MOD2022/0220

## PROPOSED ALTERATIONS & ADDITIONS

WISEMAN RESIDENCE 63 MARINE PARADE AVALON BEACH MARCH 2019 (MOD APRIL 2022)

DWG 0319 1/5 SHIMDESIGN architectural design and drafting k2shimeld@gmail.com

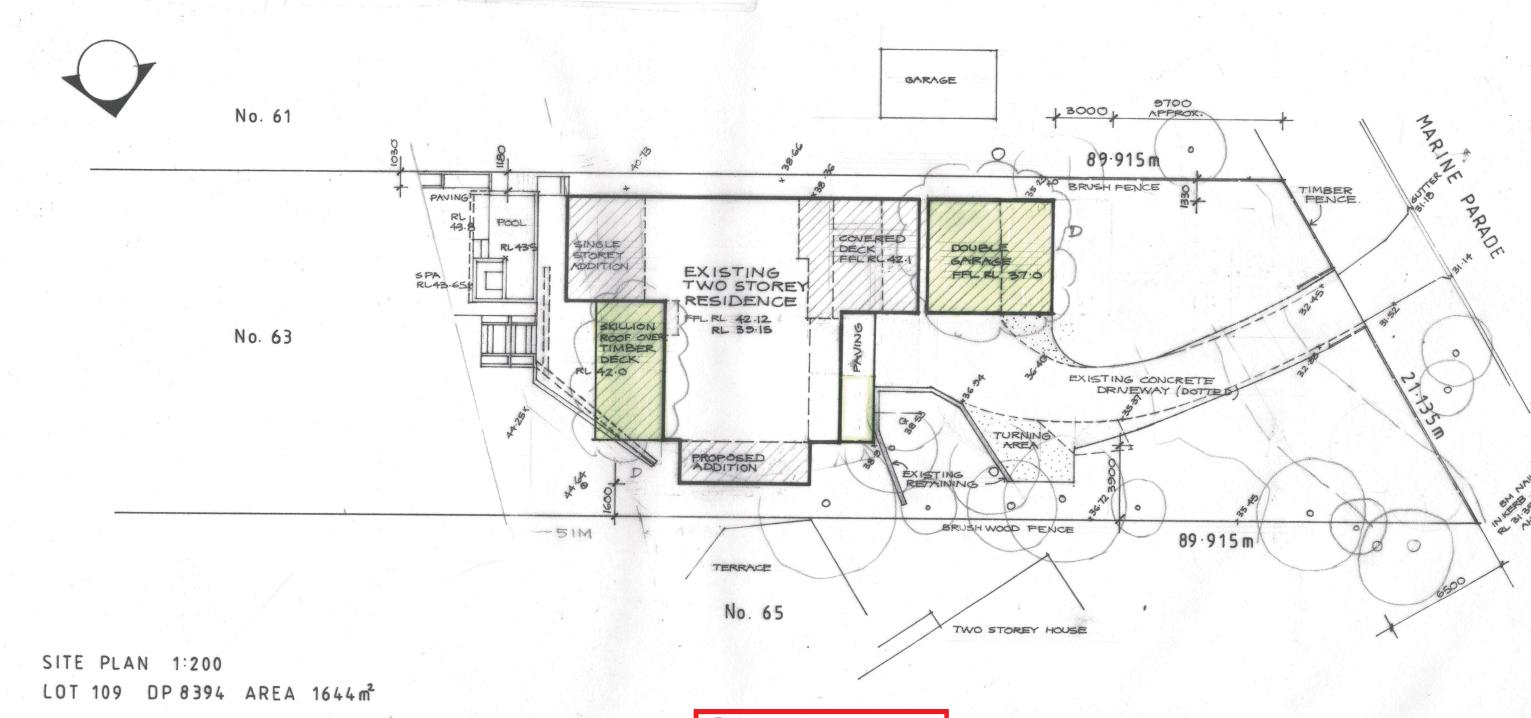
14.4.21 DELETE SECONDARY DWELLING / REDUCE FRONT DECK

12.5.20 POOL DECK DELETED/ CONDITIONS OF CONSENT FOR C.C.

10-12-14 MODIFICATION TO DA NO 263/14

2411 14 REDUCE ROOF TO DECK / DELETE CABANA ROOF PERGOLA IN LIEU.

DWG 0319 2/5 SHIMDESIGN architectural design and drafting k2shimeld@gmail.com

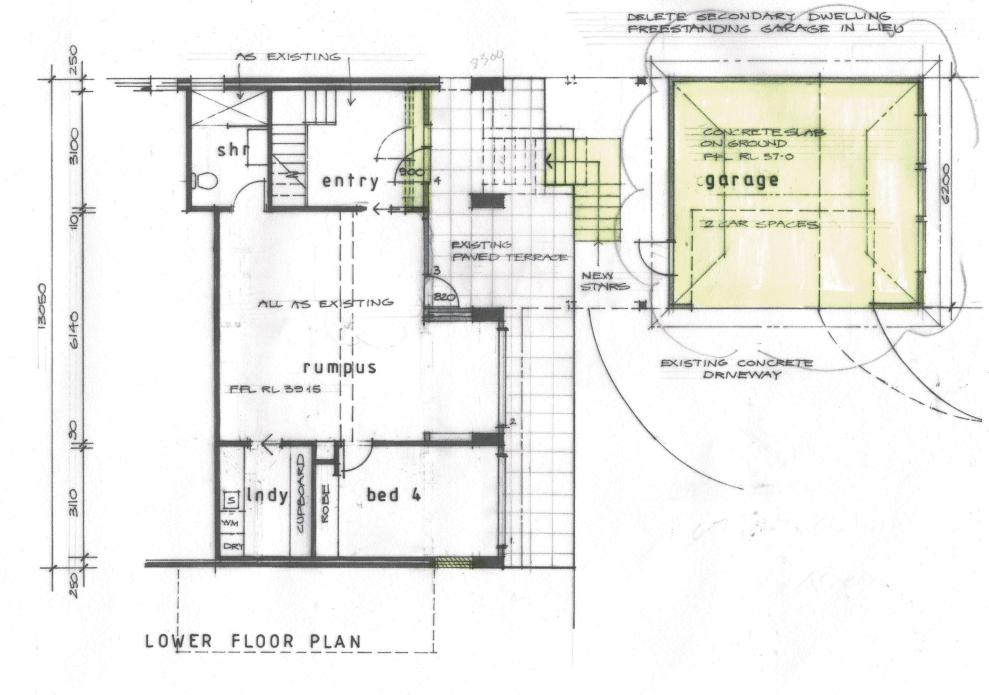
D. 14.4.2020 DELETE SECONDARY DWELLING FREE STANDING DOUBLE GARAGE IN LIEU RETAIN EXISTING ENTRY, STAIR, RUMPUS ROOM AND BATHROOM.
